CITY OF PORTLAND, MAINE
HISTORIC PRESERVATION BOARD

HISTORIC PRESERVATION BOARD AGENDA
April 15, 2015, 5:00 p.m. - Room 209, Portland City Hall

**PUBLIC HEARING
276 STATE STREET**

RE: April 15, 2015 Public Hearing - Review of Proposed Rooftop Addition

Enlarged Revised Dormer from State St

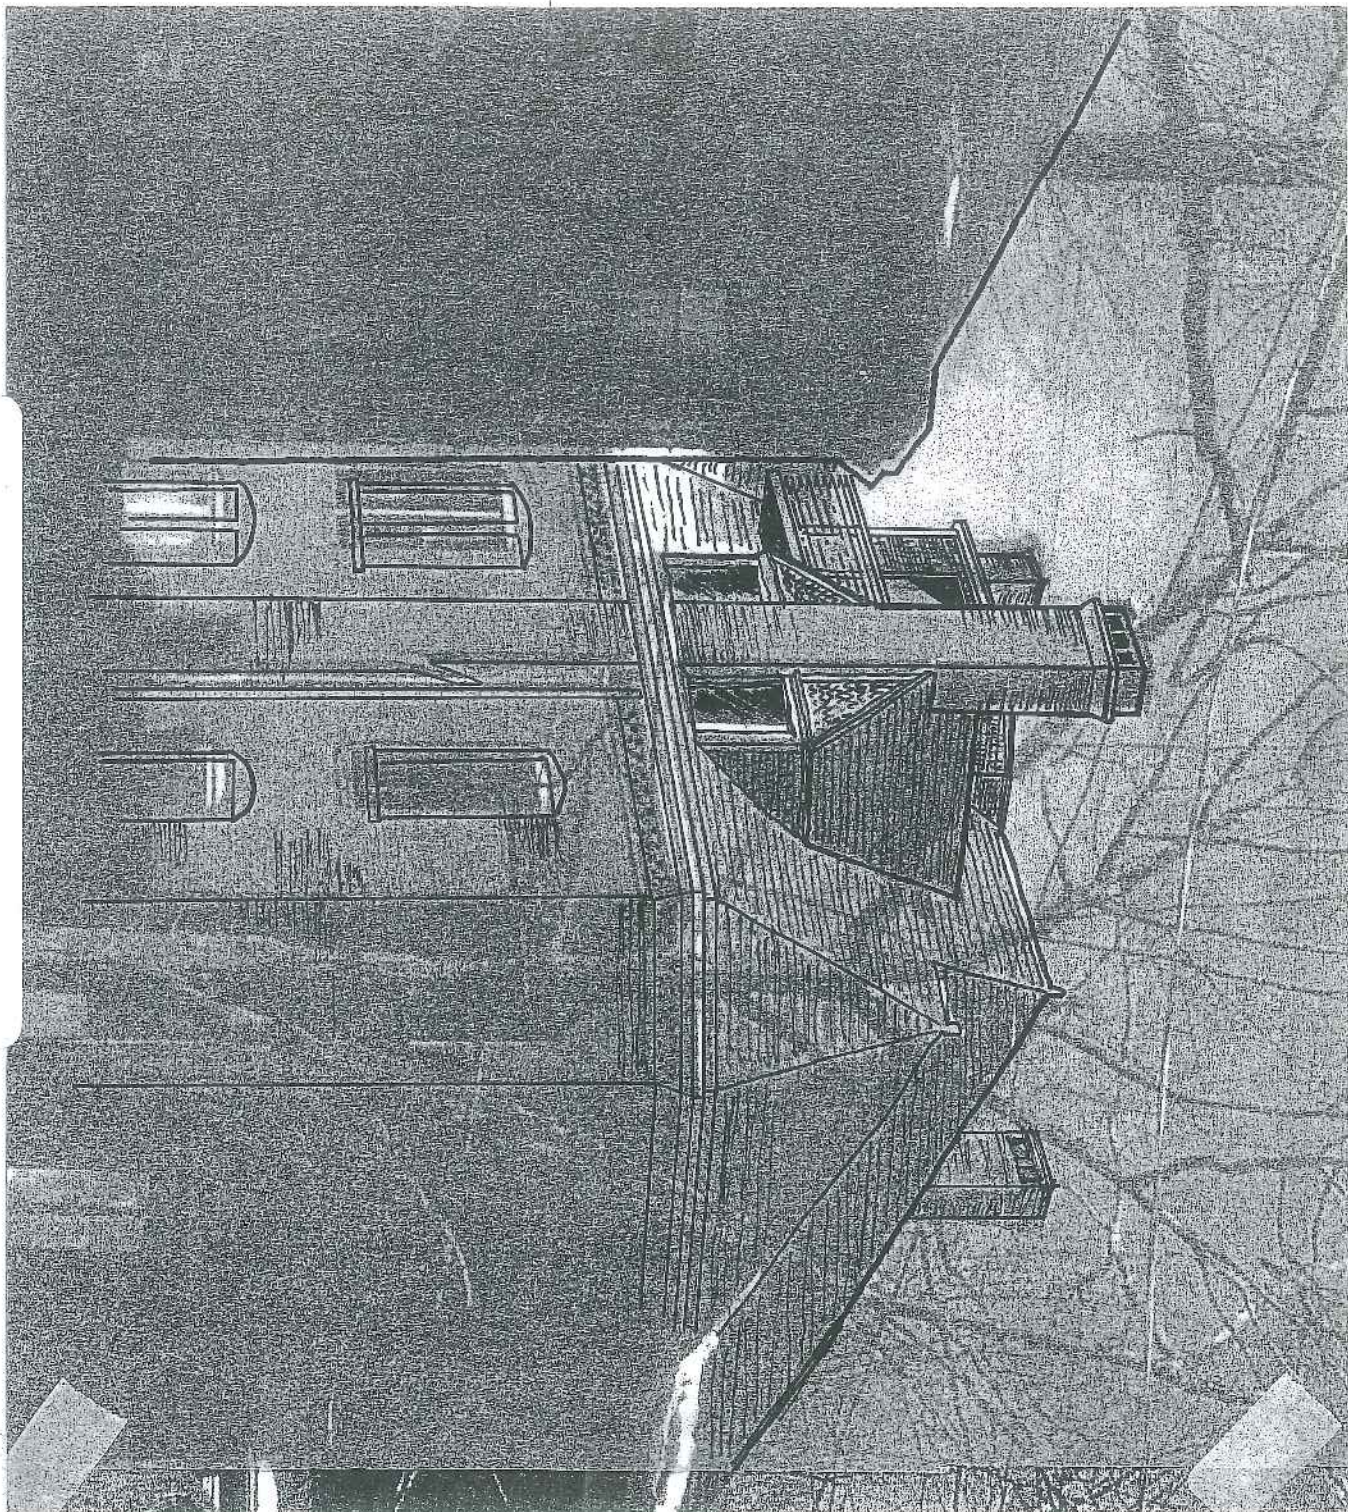
Once again, Mr. Sengelmann's description and drawings convey his concept quite clearly, and how the adjustments made in response to the workshop comments have changed the anticipated appearance. The drawings submitted demonstrate how the reduction in width of the proposed north dormer has reduced its mass and its footprint on the original roof plane.

The architects' latest proposal for the south dormer shows a reduction in visual impact, but not complete invisibility. Both the dormer face and the edge have been pulled back to reduce what can be seen beyond the existing original dormer and chimney. In the case of both dormers, and as with the original proposal, the finishes and materials are chosen to fit in with the existing palette.

Staff believes the Board may find the revised north dormer proposal compatible with the historic original structure. More details will be required concerning the windows proposed for its face, and members may want to discuss the choice of casement windows and any stylistic details that might assure visual compatibility.

In the case of the south shed dormer and balcony, the Board must grapple with whether the limited visibility of the proposed alteration is acceptable. The architects and owners appear to feel they have reduced the size and visibility of the construction as much as they can, without sacrificing the benefits of the attic expansion. The owners no doubt feel these proposed alterations will improve the livability of their condo. A central question for the Board is whether, as in Standard for Review of Alterations # 1, this would be a "compatible use ... which requires minimal alteration to the character-defining features of the structure...." Mr. Sengelmann argues that only from a short stretch of State Street will the view shown in rendering F-13 be visible, and only when the mature street trees are leafless. Nonetheless, the Board must decide whether this is acceptable.

A001

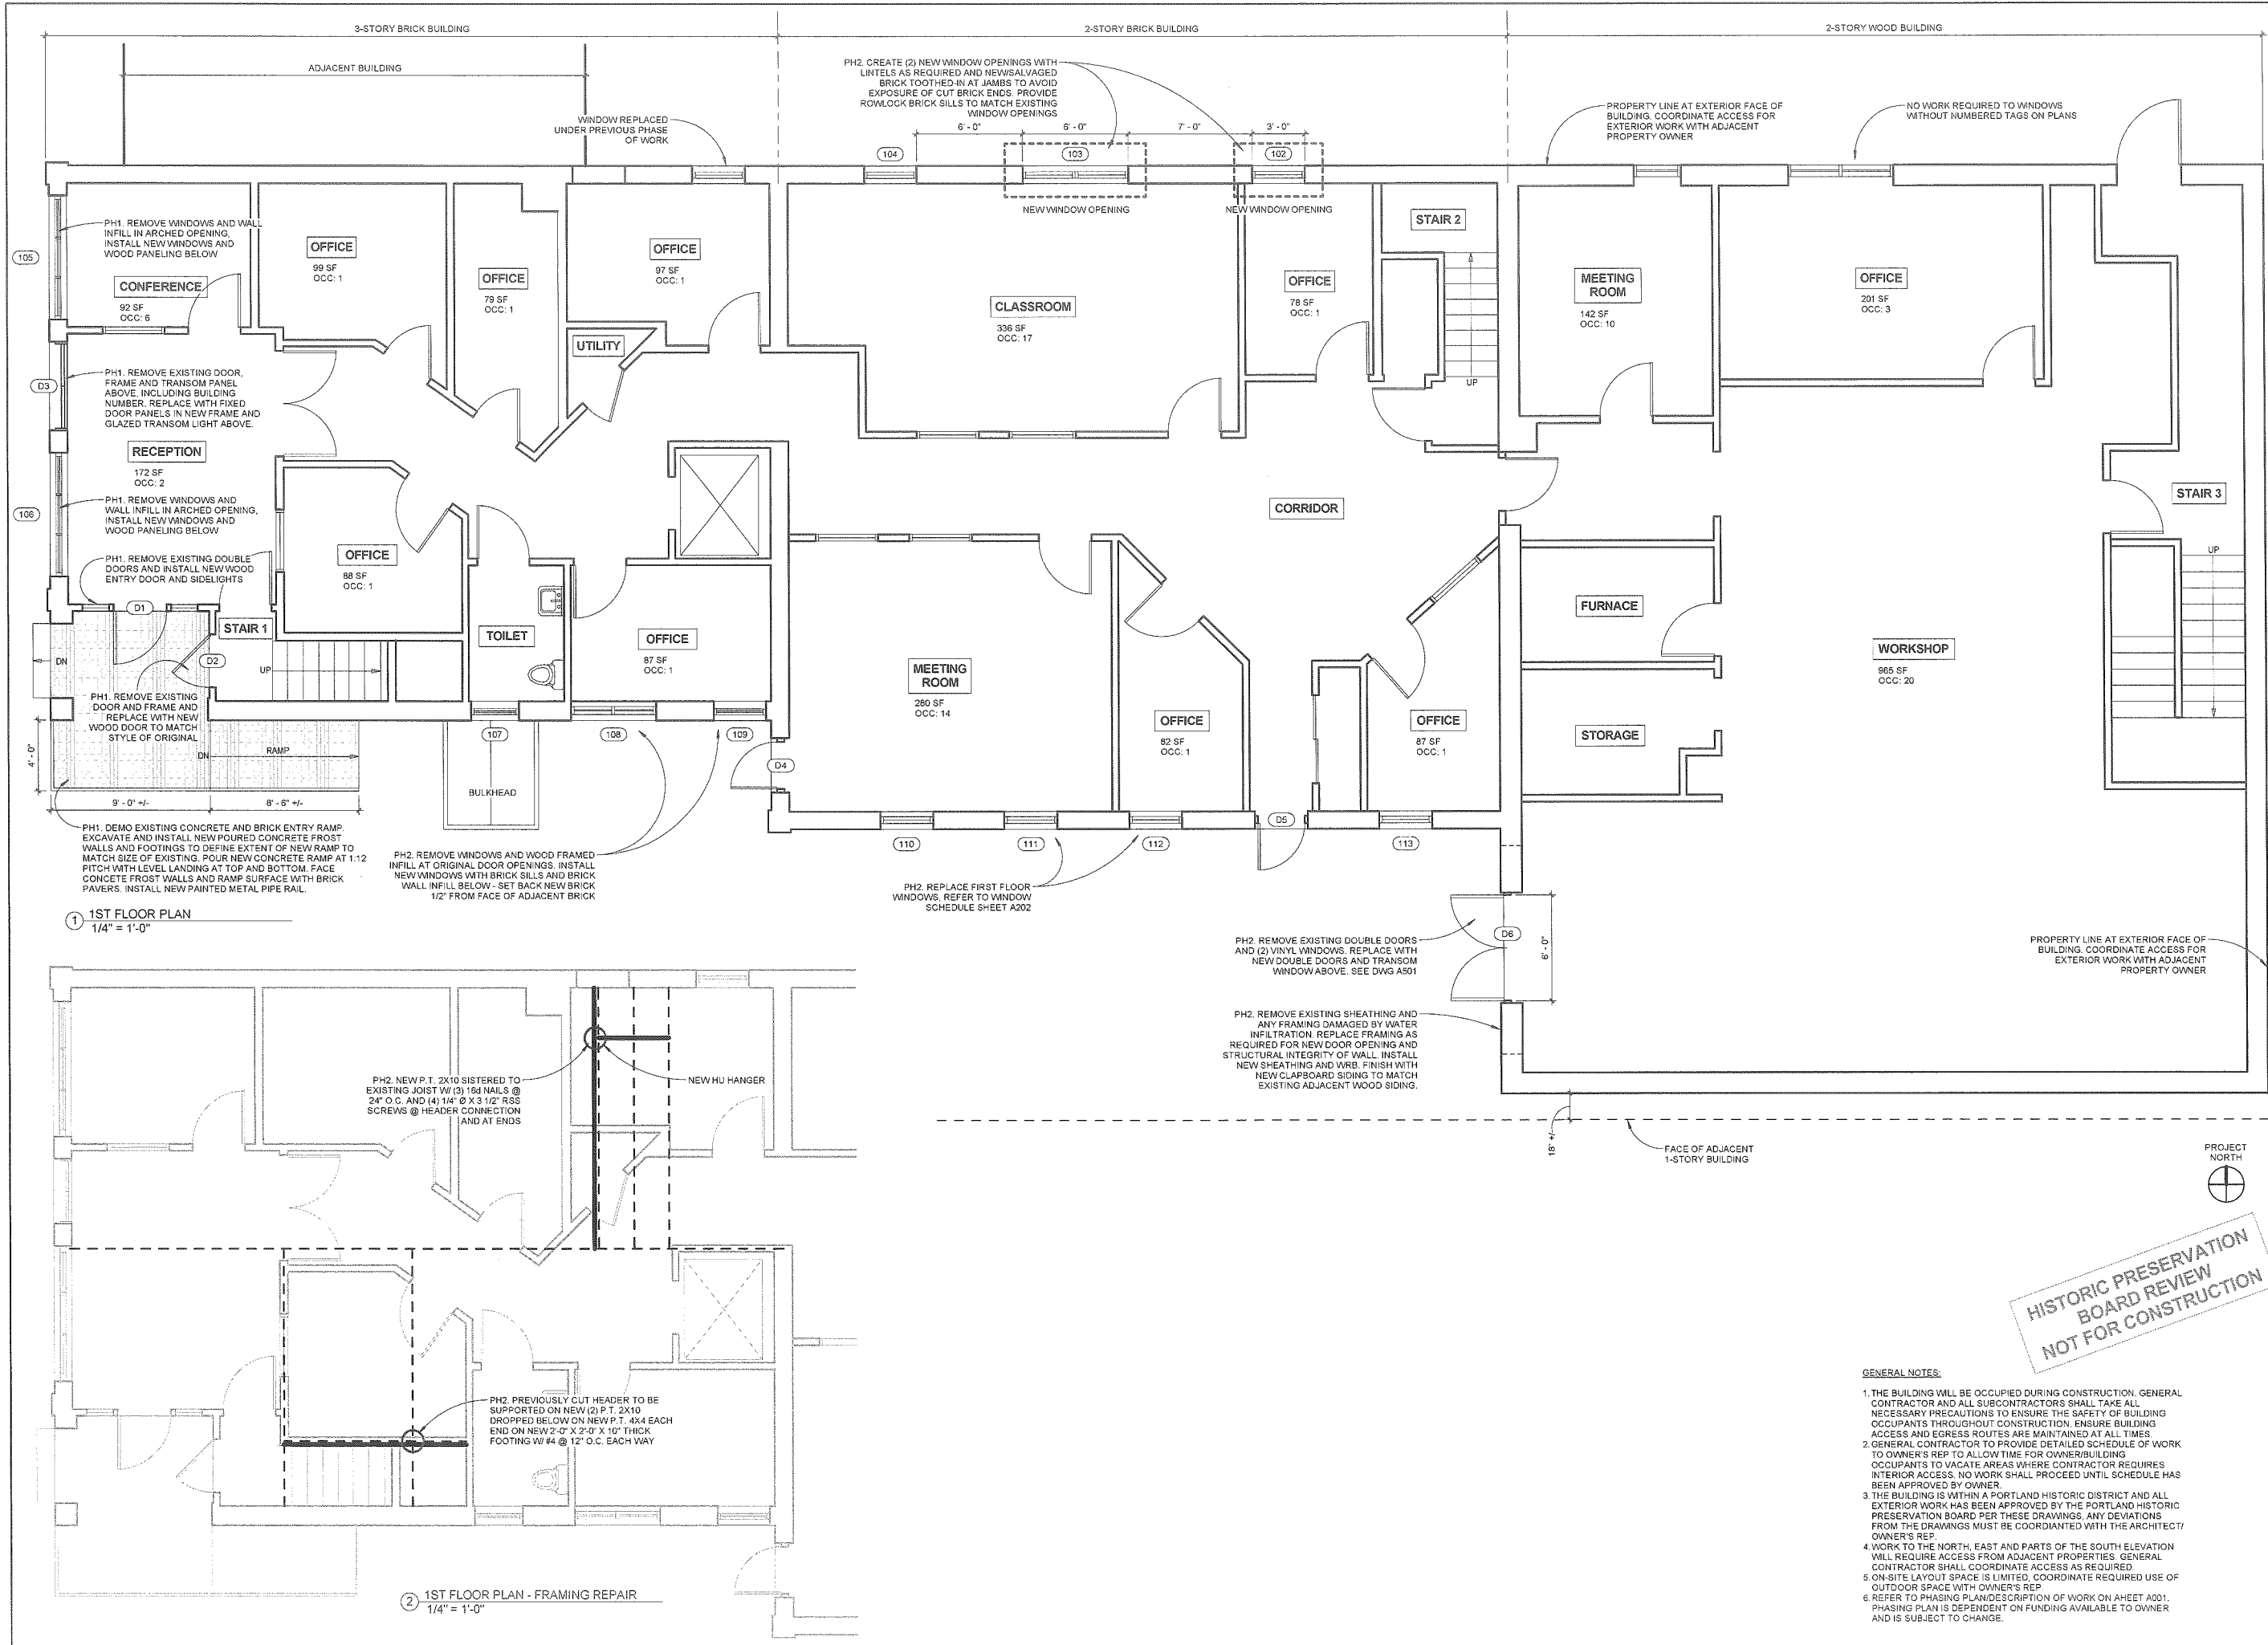
The title page of the architects' plans lists the work proposed for each phase, and some detailed specifications and product sheets are included. Perhaps the review of this large, multi-phased project should begin with reviewing the priorities proposed, and the general

① STOREFRONT
1" = 1'-0"

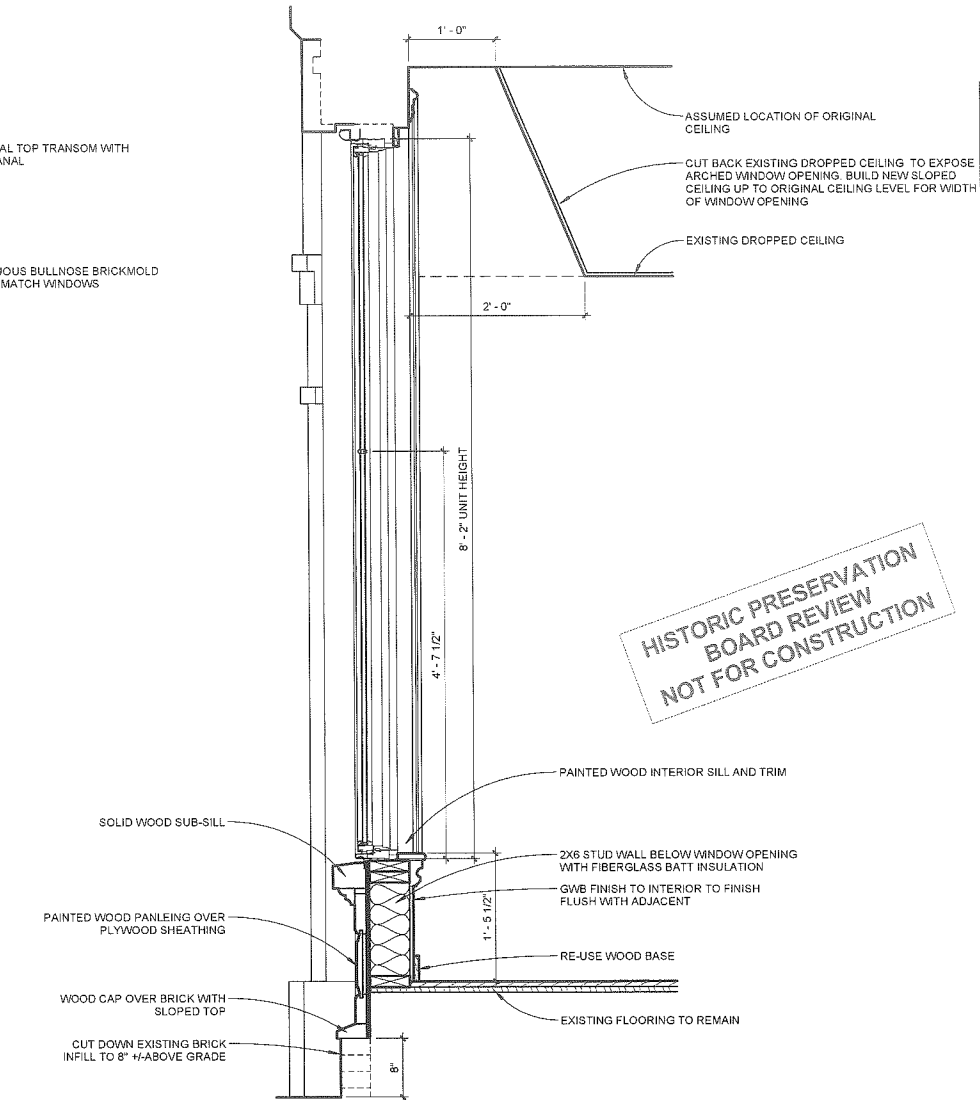
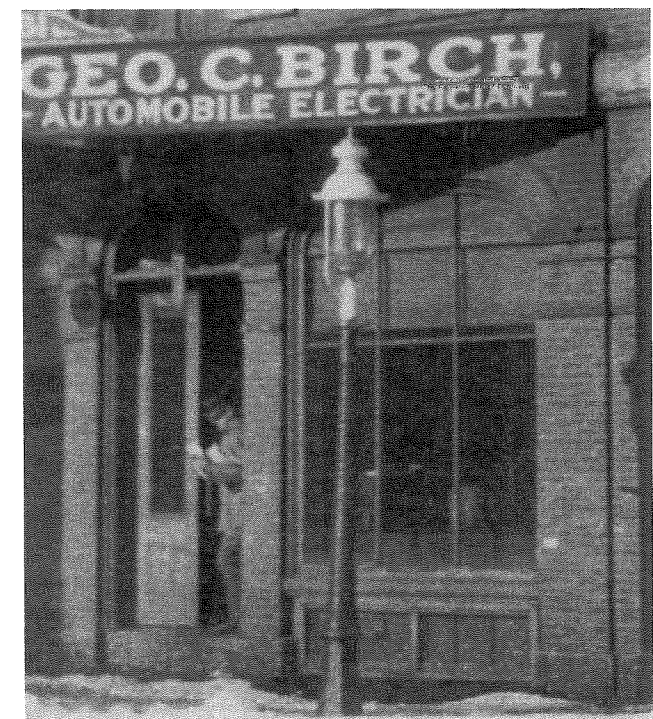
In addition to more general review of alternative materials such as: clad windows, aluminum gutters (existing) and composite trim, the Board will probably wish to pay particular attention to the windows and doors in the storefront. Staff questions whether storefront windows should be clad as proposed (like other window replacements,) or if painted wood would be more appropriate for a more historic street appearance.
